**SOUTH DAVIS SEWER DISTRICT**

**ADDENDUM NO. 2**

**NORTH PLANT UPGRADE PROJECT**

**April 29, 2024**

DRAWING NO.  
**G019**  
SHEET

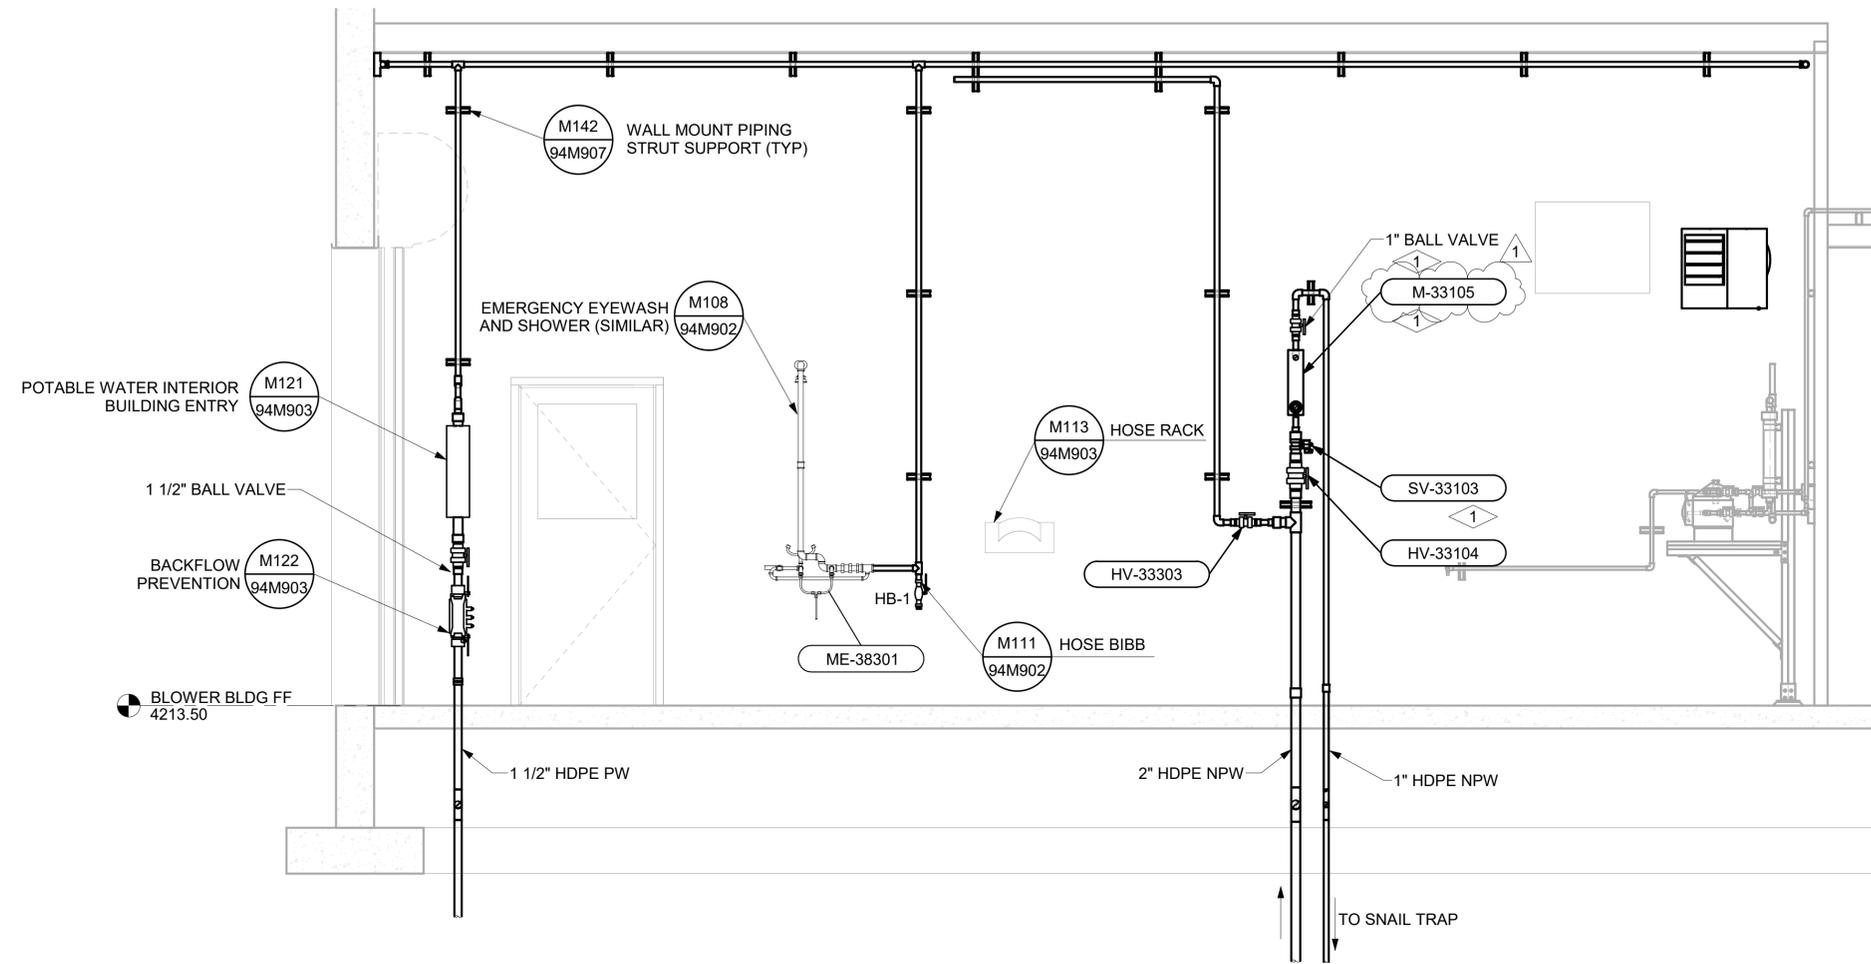
- 1.18** The coating schedule G019 indicates that the walls and floor of the wet well should be coated. This is incorrect, only the walls and ceiling should be coated. The coating schedule G019 has been corrected to reflect this. The revised document has been attached to this Addendum.

- 1.19** No coating is required on any existing/modified manholes. Coating schedule G019 has been updated to reflect this.
- 1.20** Tempered water will not be provided to site eyewashes or showers. Water heaters and associated equipment will not be installed.

DRAWING NO.  
**69M206**  
SHEET

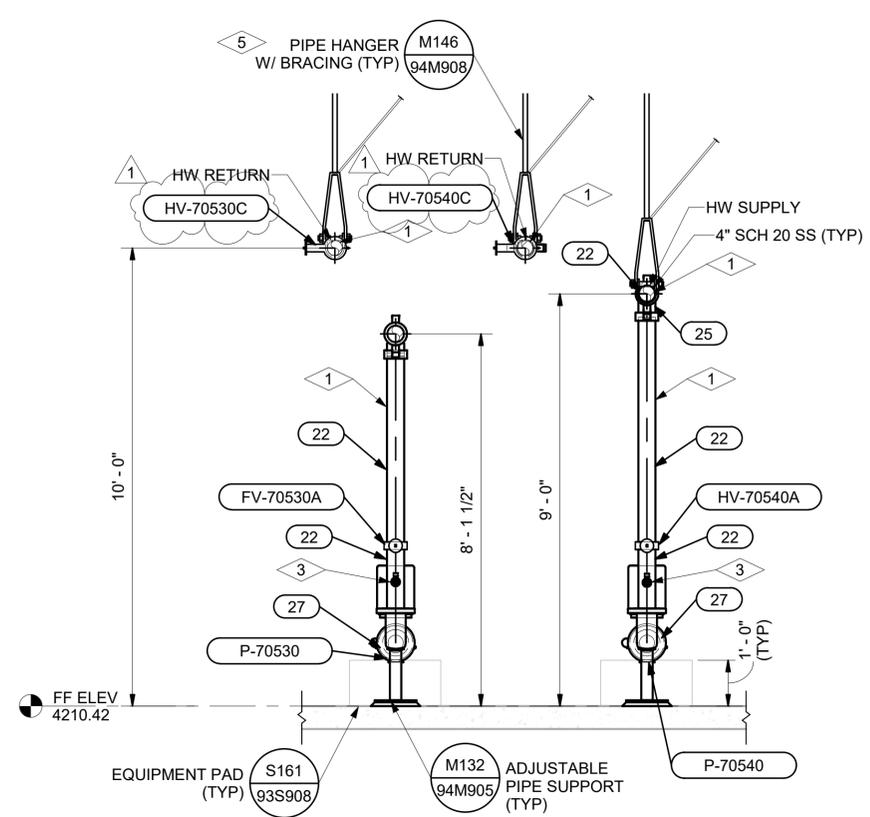
- 1.23** On drawings 69M206 and 69M405, butterfly valves HV-70530D and HV-7040D were mislabeled. They have been relabeled as HV-70530C and HV-7040C, respectively. The updated drawings (69M206 and 69M405) have been attached to this addendum.

- 1.24** On drawing 69M206, the meters shown as M-70531 and M-70541 have been removed from the drawing.
- 1.25** Suction diffusers ME-70521 and ME-70526 are shown on mechanical drawing 69M206 and 69M405. These diffusers have been added to the mechanical schedule on sheet 81M803 and P&ID sheet I125.

DRAWING NO.  
**69M409**  
 SHEET

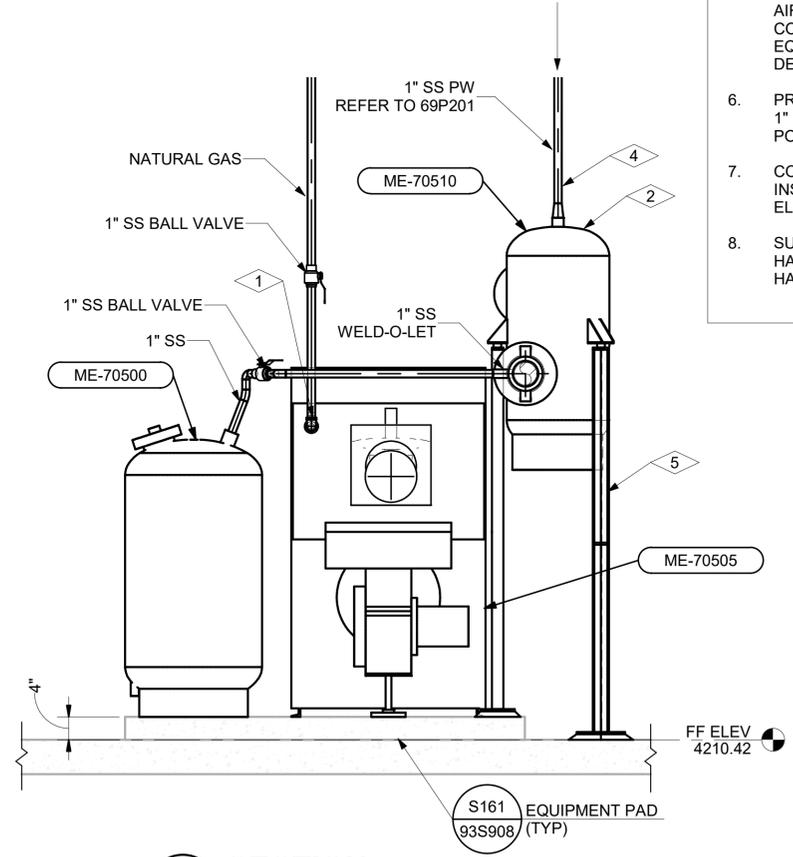
- 1.26** On drawing 69M409, valve HV-7501 was mislabeled. It has been relabeled as HV-70501. The updated drawing has been attached to this addendum.
- 1.27** Fittings 40 and 48 shown on the pipe schedule were mislabeled on drawing 69M801 as “SCH 40 SS” and have been updated to read “SCH 40 WS.” The hot water piping shall all be welded steel, and the biogas piping shall be stainless steel. The pipe schedule on 69M801 has been updated to reflect this and is included in this addendum. No dissimilar metals should be connected in the digester building.

DRAWING NO.  
**06M201**  
SHEET

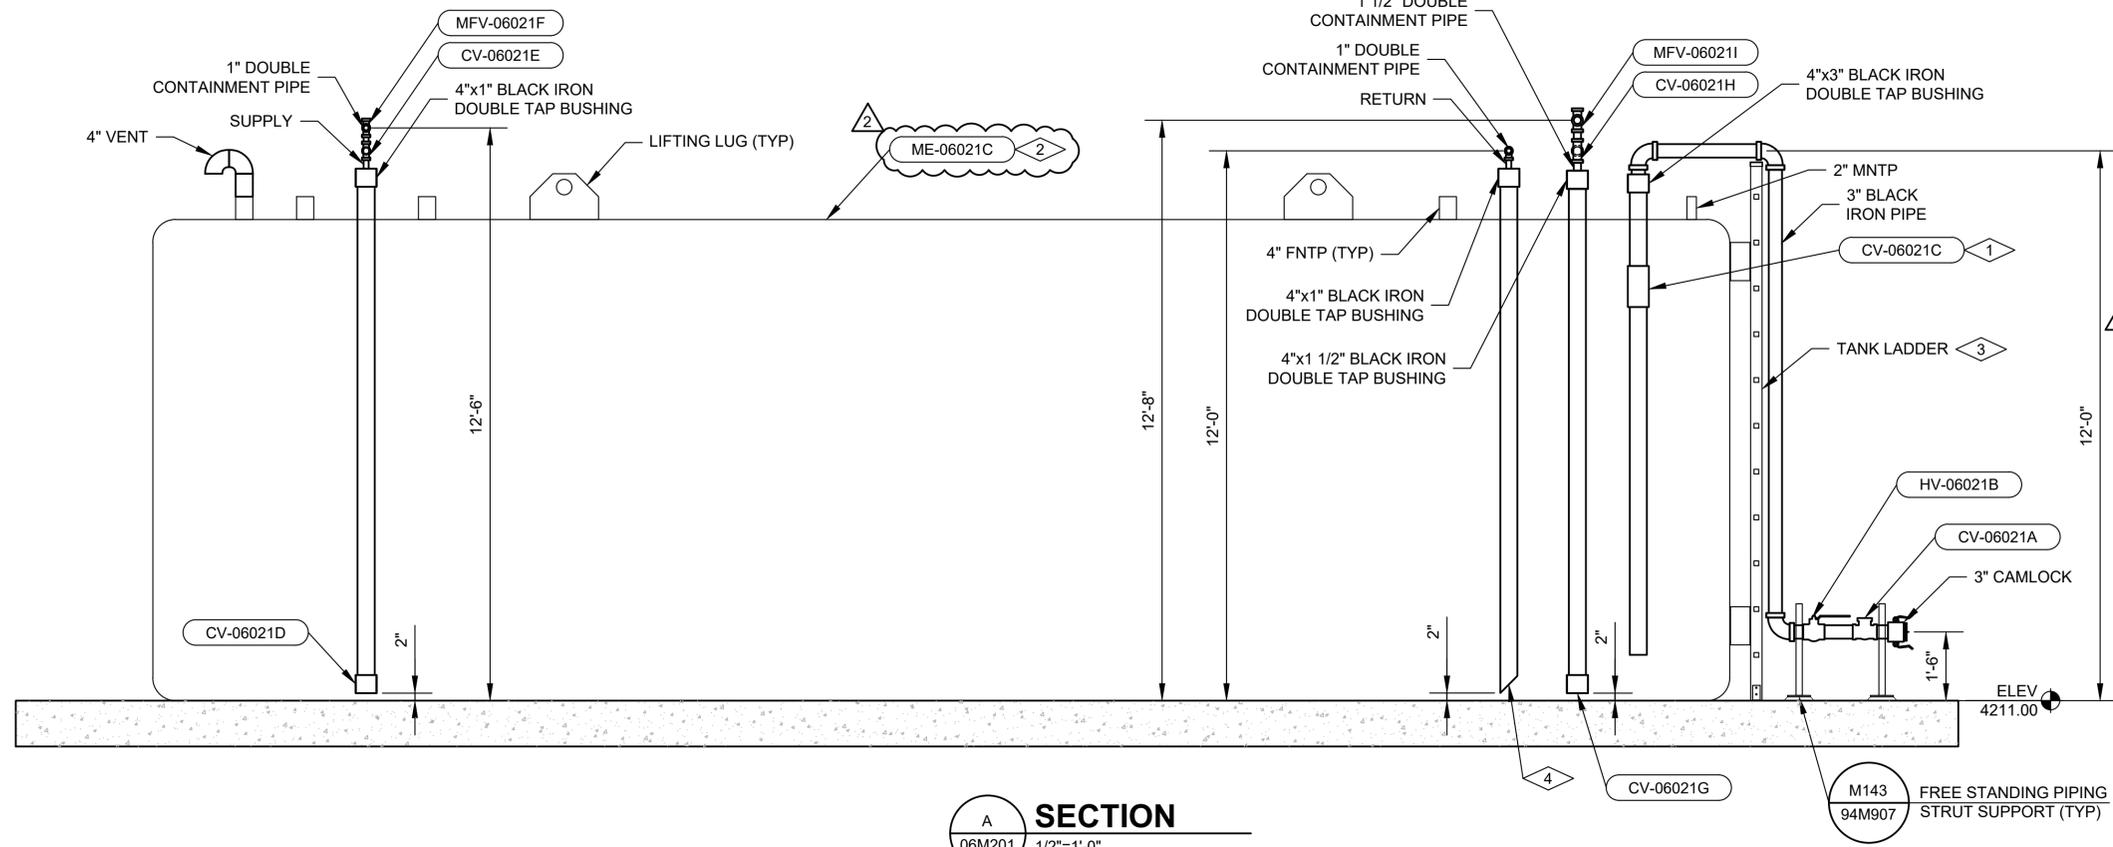
- 1.28** On drawings 06M201, 06M401, and 06M402 the diesel tank was mislabeled as ME-06011. The tag number have been updated to ME-06021C. The updated sheets are included in this addendum.

- 1.29** Contractor shall coordinate final fuel piping layout between diesel tank and generator upon approval of final submittals for those equipment. General Note 5 has been added on sheets 06M201, 06M401, and 06M402 to reflect this. Additionally, some incorrect keynote labels have been updated. The updated sheets are included in this addendum.
